Piper Aircraft, Inc.
2926 Piper Drive
Vero Beach, Florida, U.S.A. 32960

SERVICE NO. 1197B

Date: May 3, 2010 (S) (M)

CONTROL WHEEL SHAFT INSPECTION

Figure 1
Control Column Assembly

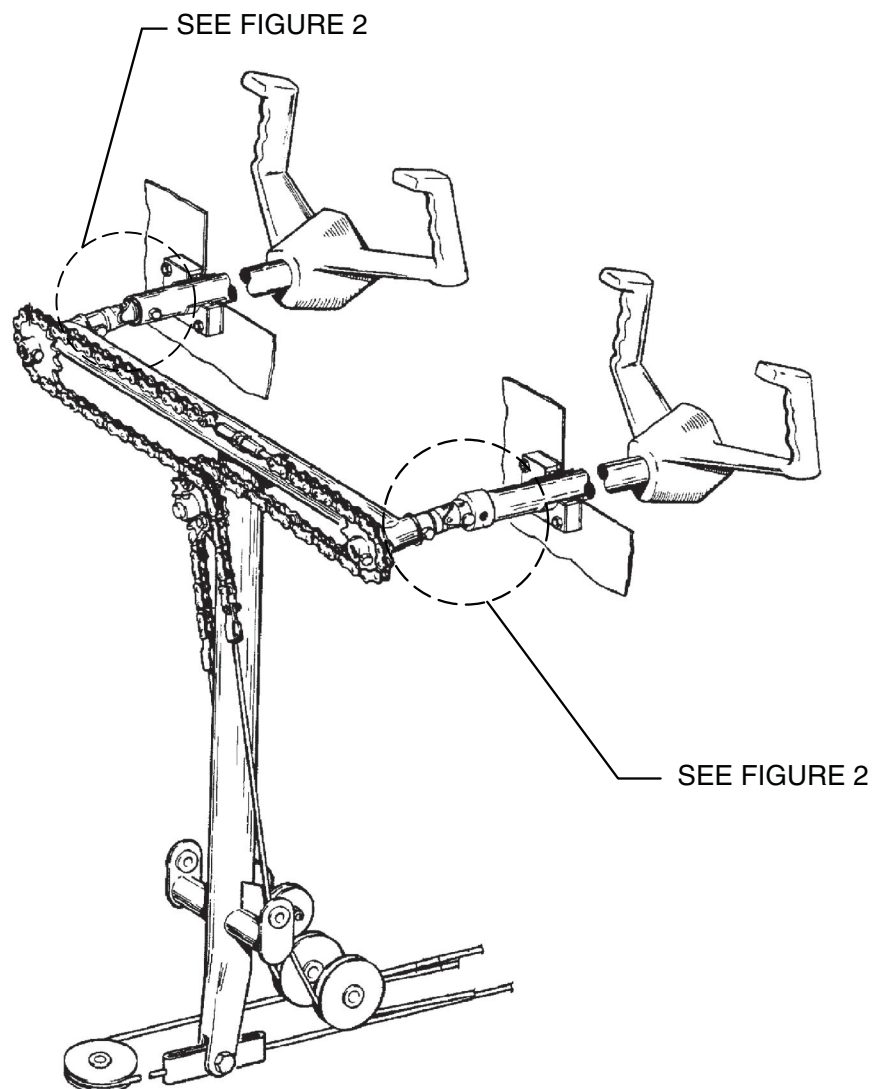
1. Gain access to the forward end of the control wheel column between the instrument panel and the forward firewall.
2. Locate the shaft and the universal joint (2 per aircraft), which are fastened together with a threaded taper pin, as shown in Figures 1 and 2. These components are installed on the aft side of the T-bar assembly.

Figure 2
Shaft Fastened to Universal Joint

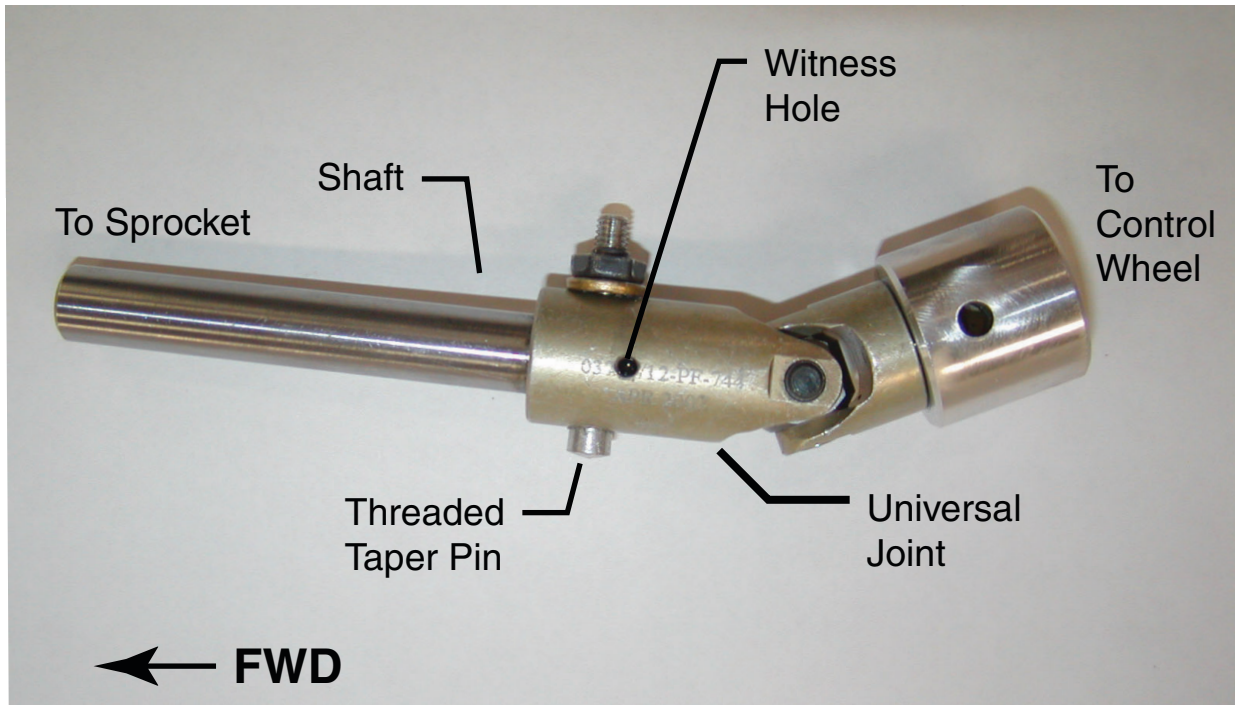
3. Inspect each universal joint for the presence of a witness hole, as shown in figure 2. Most aircraft will have this witness hole feature. However, some early model aircraft may not have a witness hole. If no witness hole exists, proceed to step 5.

4. Insert a 3/64 inch diameter drill rod into each witness hole as far as it will go with hand pressure. Measure the depth of penetration:
 - If the drill rod penetration depth measures approximately 0.2 inches, this indicates that the drill rod is bottoming out against the near side of the fully inserted shaft. This installation is correct. Proceed to step 8.

- If the drill rod penetration depth exceeds 0.2 inches, this indicates that the drill rod is bottoming out against the far side inner wall of the universal joint, and is not making contact with the shaft. Universal joints with this condition may have a shaft with inadequate edge distance, and will require further inspection. Proceed to step 5.

5. If the inspection from step 3 identifies a universal joint without a witness hole, or if the inspection from step 4 identifies a shaft with potentially inadequate edge distance, temporarily remove the taper pin (or bolt, as applicable) and disassemble the universal joint from the shaft.

- If the distance from the end of the shaft to the centerline of the hole for the taper pin (or bolt) measures 0.19 inches or more, the edge distance is adequate, and existing parts may be reassembled. Proceed to step 7.
- If the distance from the end of the shaft to the centerline of the hole for the taper pin (or bolt) measures less than 0.19 inches, the edge distance is inadequate, and replacement of the shaft is required. Proceed to step 6.

Figure 3
Taper Pin Protrusion

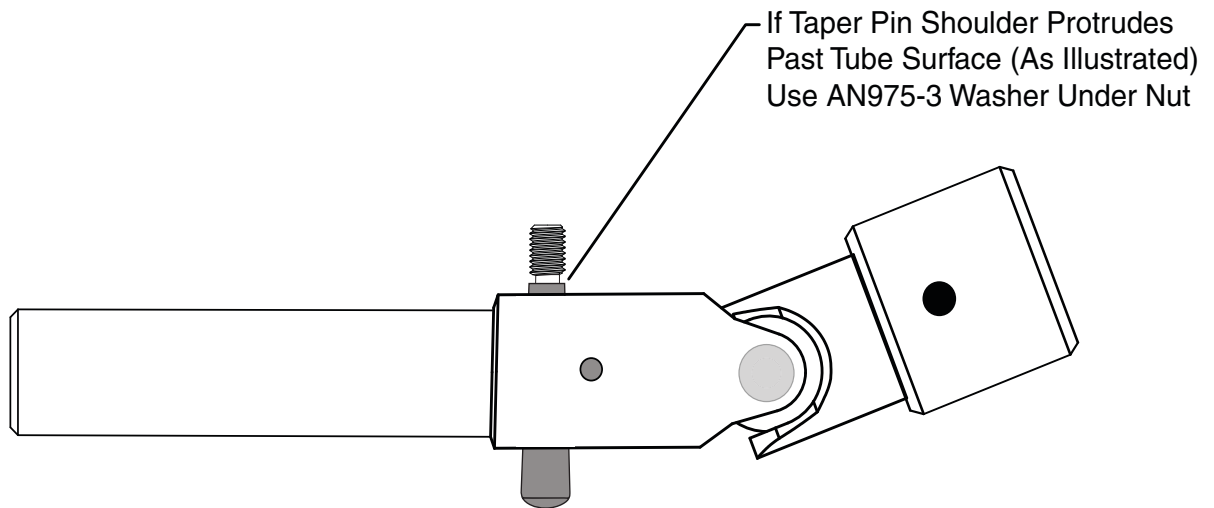
Install tapered pin through mated parts. (See Figure 3). Install the appropriate washer under the nut, using the following criteria:

- If pin shoulder (small taper end) does not protrude past outer surface, install an AN960-10 washer (Piper part number 407-564) under nut.
- If pin shoulder (small taper end) protrudes past tube surface, install an AN975-3 washer (Piper part number 494-093) under nut.
